BUILDING COMPLETION REPORT.

PLAN FOR BUNGALOW ON PLOT No. 52/4, J.M.3 (AMENITIES)
SHIKARPURI CO-OPERATIVE HOUSING SOCIETY.

Reference No. L. C. P. 216/38.

With reference to your application dated 9th February 1939 with a plan for the proposed buildings/additions and alterations on plot No. 52/4 Survey Sheet No. J.M.3 Jamshed Quarter, I have to request you to comply with the following requirements:—

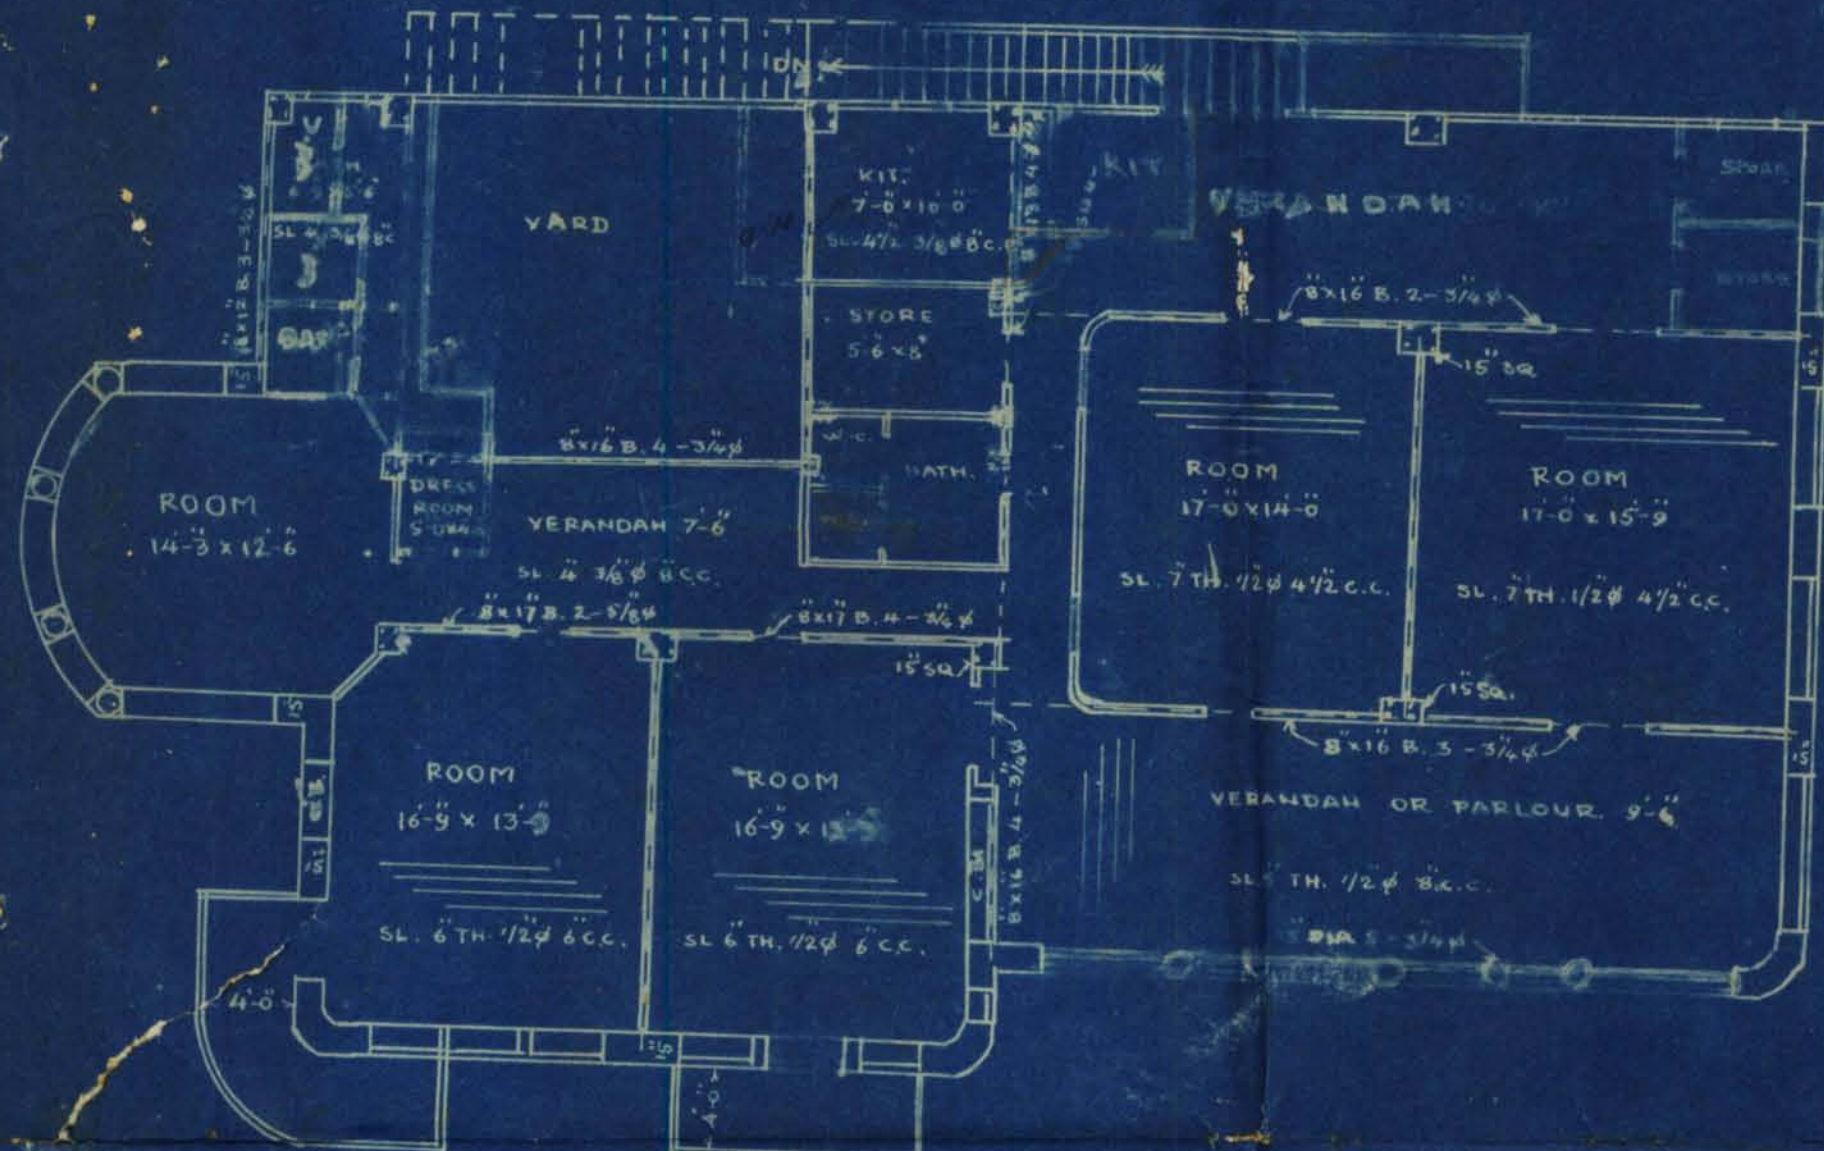
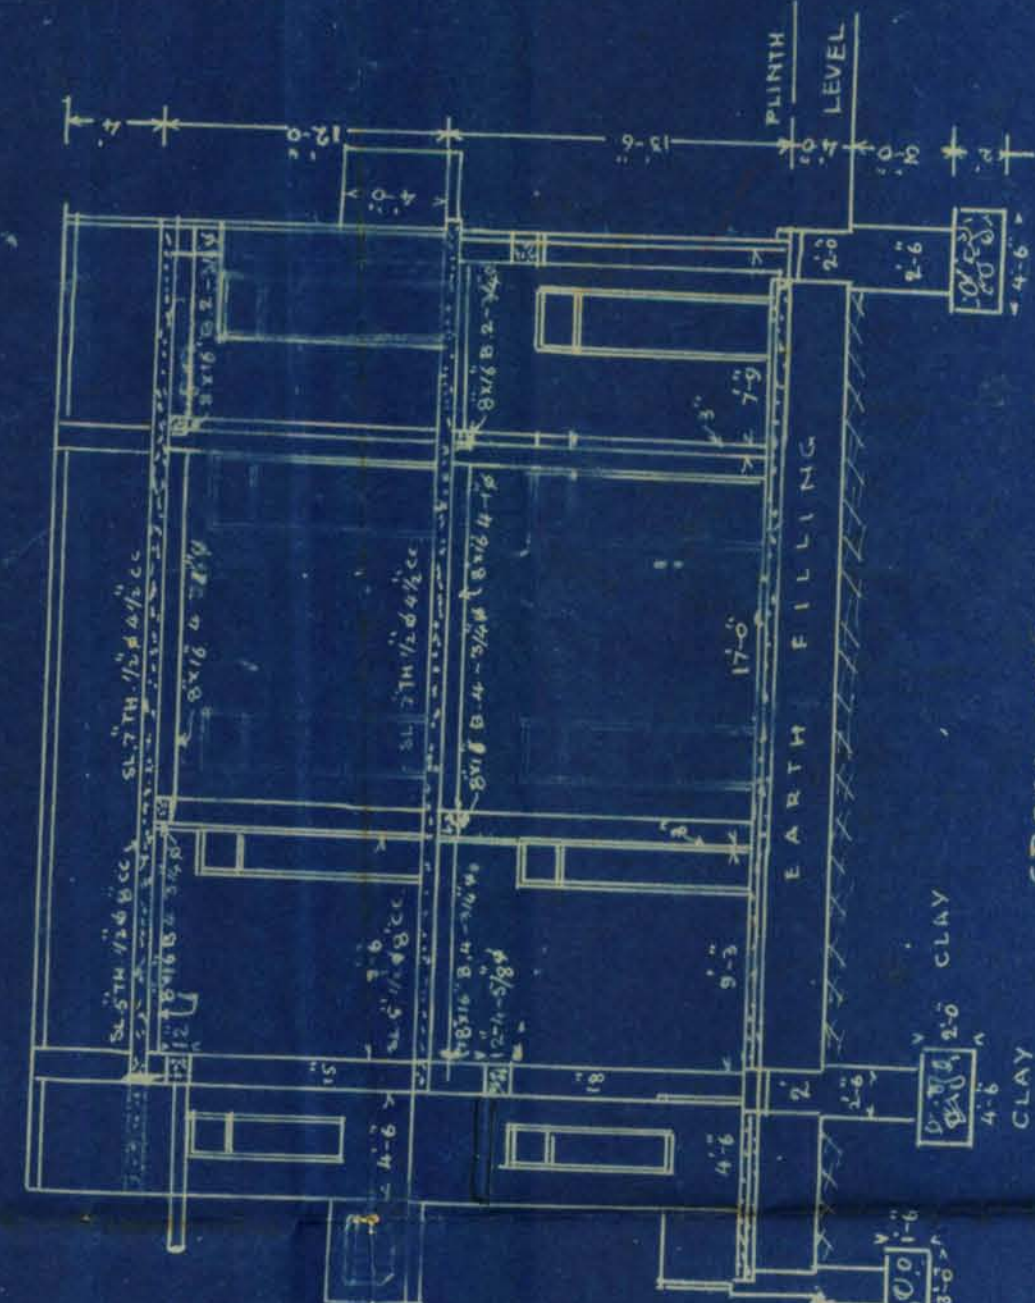
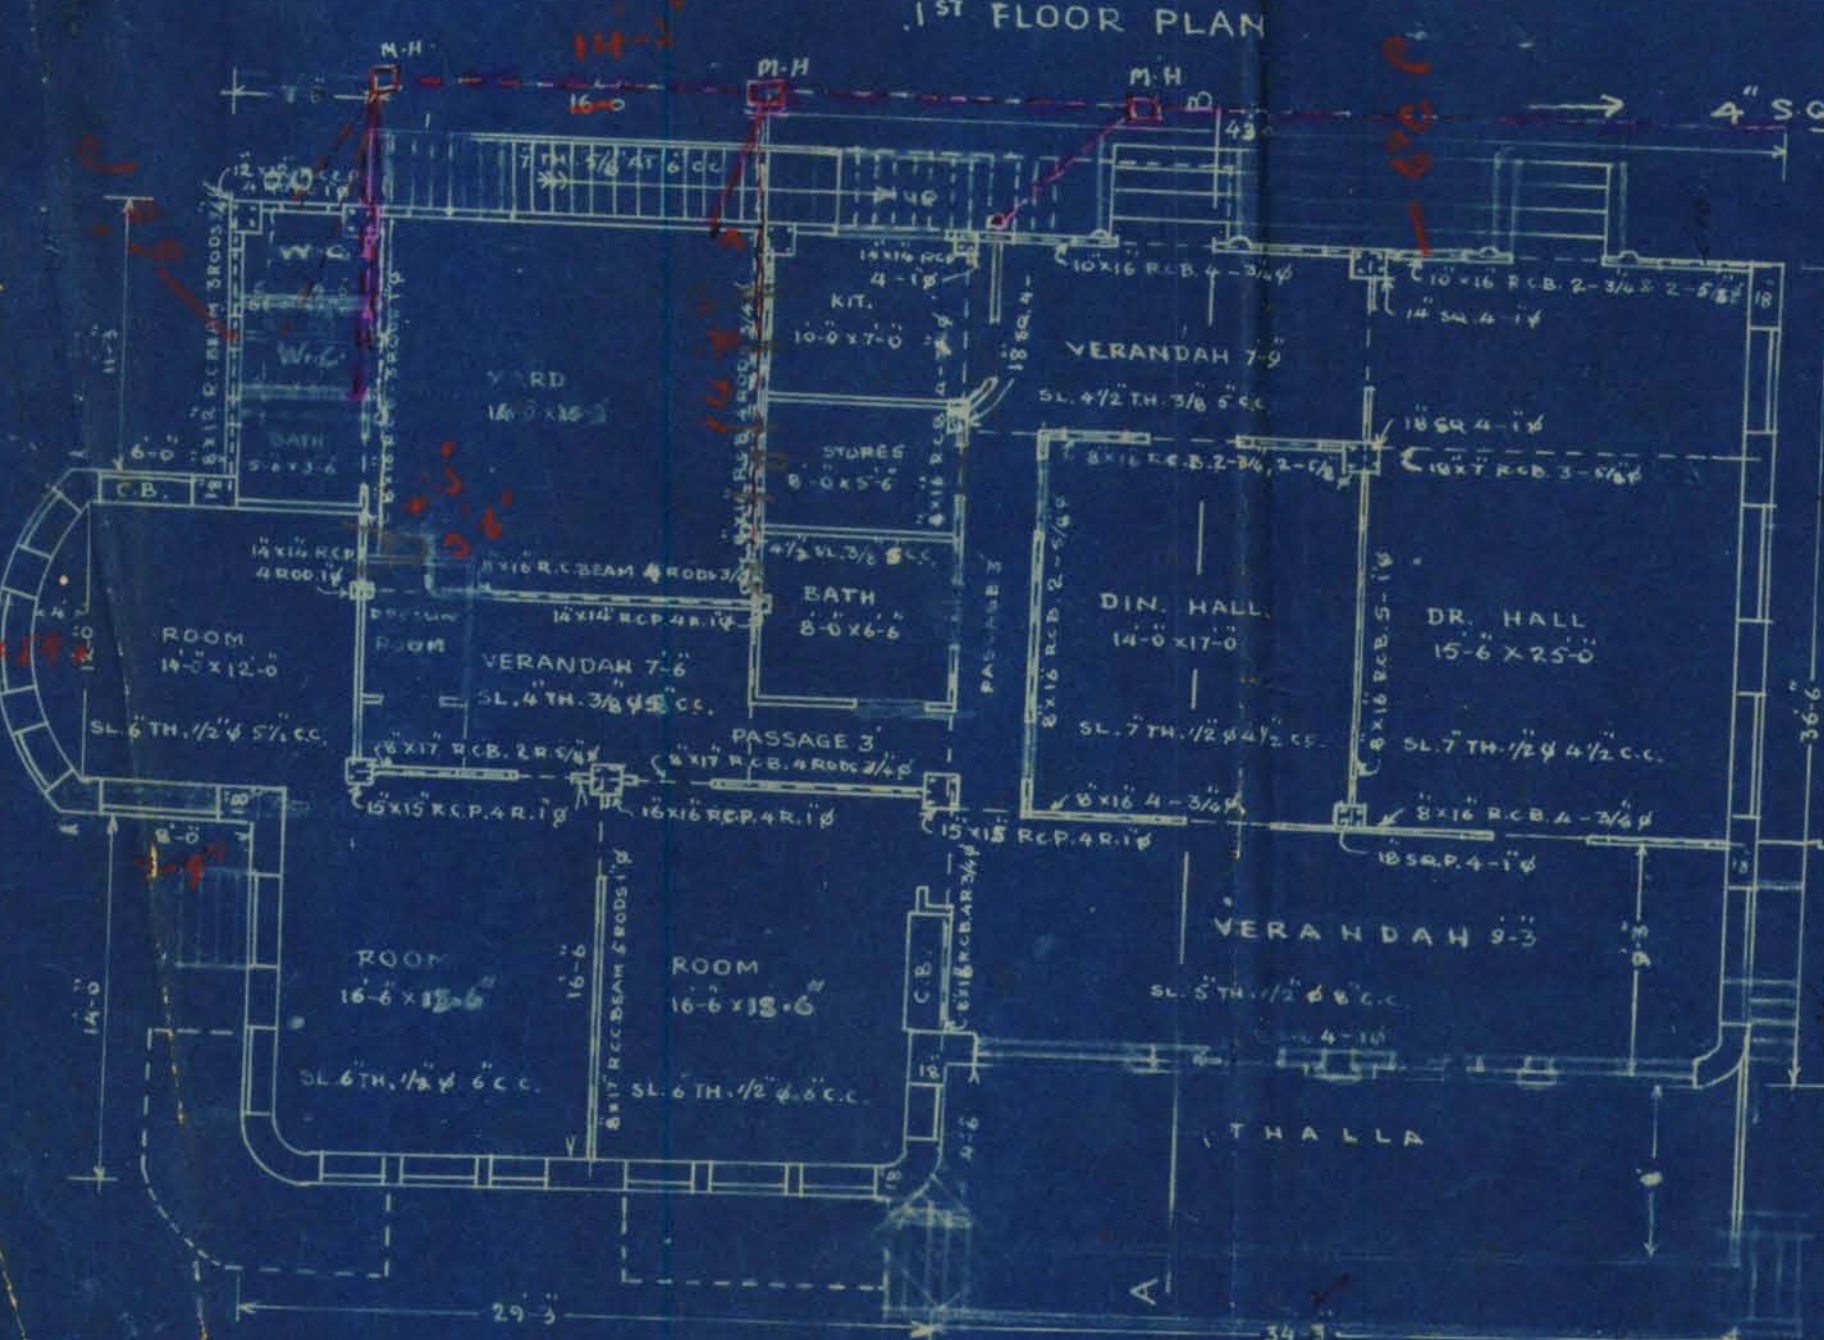
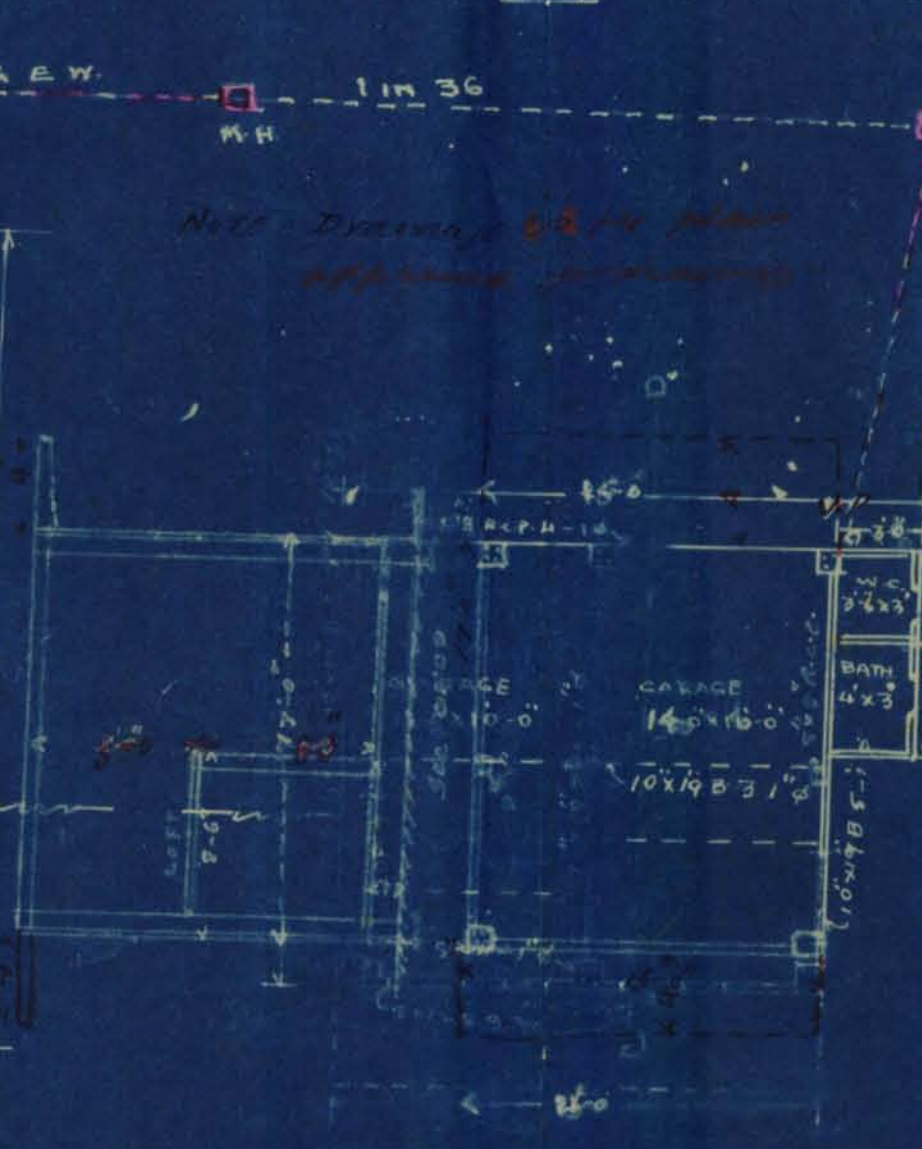
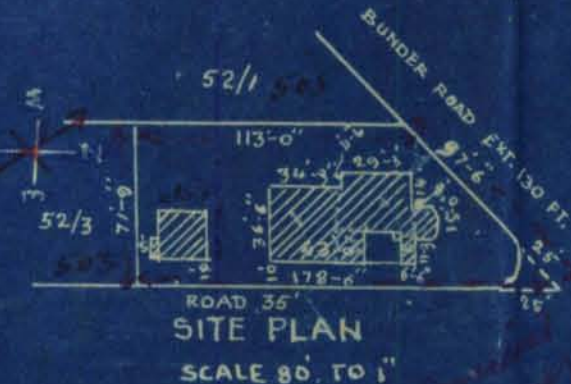
1. Drainage lines are not shown correctly as per approved plan for drainage.

2. Measurements must be arrow marked.
3. Cardinal direction be correctly shown.
4. Plot Nos. be corrected.

5. Owner must sign the plan
6. External partition to be 6" thick.
7. Height of loft in the garage must be stated clearly.
8. Architect to keep an appointment with Building Surveyor for joint measurements.

- 1.Drainage lines corrected as per plan already approved for drainage.

- 2.Measurements have been arrow marked.
- 3.Cardinal direction changed as desired.
- 4.Plot N^os given as desired.

- 5.plans have been signed by the plotholder.
- 6.External partitions have been shown as 6" thick and have been kept 6" thick.
- 7.Height of loft in the garage is 8ft and has been marked clearly.
8. Friday the 10th instt.at 10 A.M. will suit me. Building Surveyor can take the measurements on that date; however I will meet Mr.Mirza and have the date confirmed.I may also state that in case there is any difference in his measurements,which is very unlikely,I have no objection in accepting his measurements.
